RE: **Comments on Washington Street Sherborn Homes affordable housing project**

Sherborn Groundwater Protection Committee - Comments to the Select Board on the proposed Washington Street Homes 40B Development.

Subject: Water Commission Comments Regarding Washington Street Homes Proposed 40B Development

Re: Comments on Washington Homes 40B project

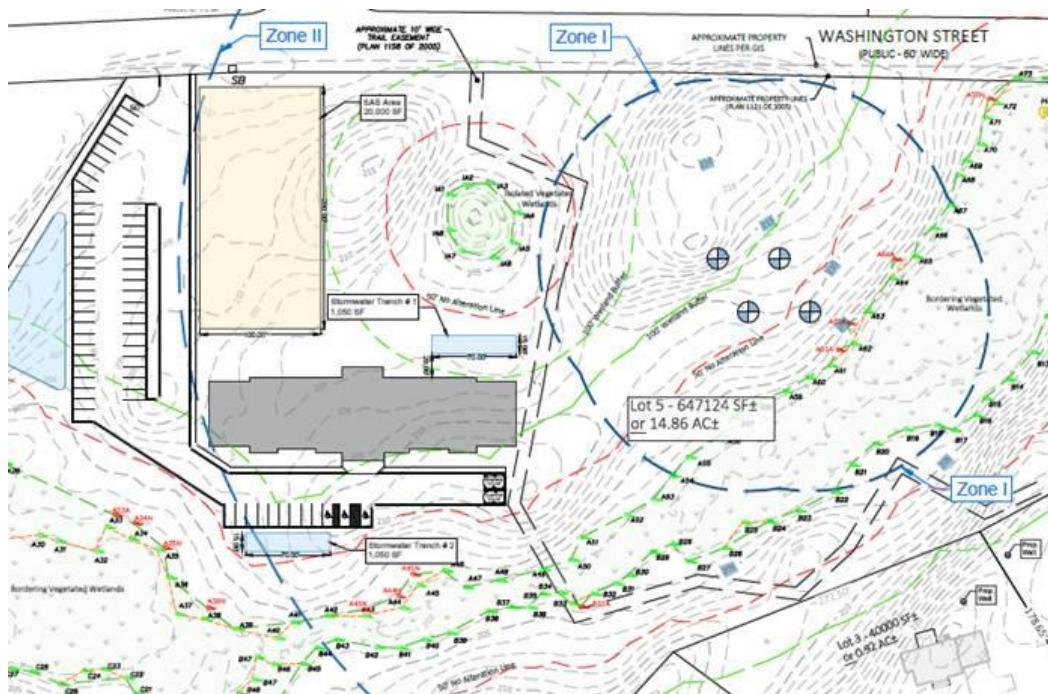
As seen by a portion of the proposed site plan inserted here, the 3-story building and paved parking area are within a few feet of the trail, and stormwater trench # 1 is also nearby. This trail brings many current residents from the areas of Greenwood St, Russet Hill Road, Washington Street, Woodland Road, and additional neighborhoods through this currently undeveloped forested wetland property. Walkers and bike riders traverse this short trail in order to get to the longer Bailey Trail, which has a trail head at the intersection of Washington St (Rt 16) and Old Orchard Road. The addition of the 40 apartment units (70 bedrooms) will increase trail use considerably.

The siting of the 3-story building and associated construction period disruption in all directions surrounding the building will impact the use and enjoyment of this trail during and after construction. To mitigate these issues can we suggest the developer consider:

1. Working with the easement title holder, the Conservation Commission, to move the trail easement some distance to the east, away from the proposed building and parking lot. The extensive wetlands on the site may complicate this, but perhaps the small trail bridging across the wetlands can be maintained, and the trail moved eastward after that section.
2. Install a cross walk with yellow safety lighting across the busy state Route 16, to a safe spot near the main Bailey Trail (Old Orchard Rd trail head) to protect the pedestrians and bikers as they cross this busy road.
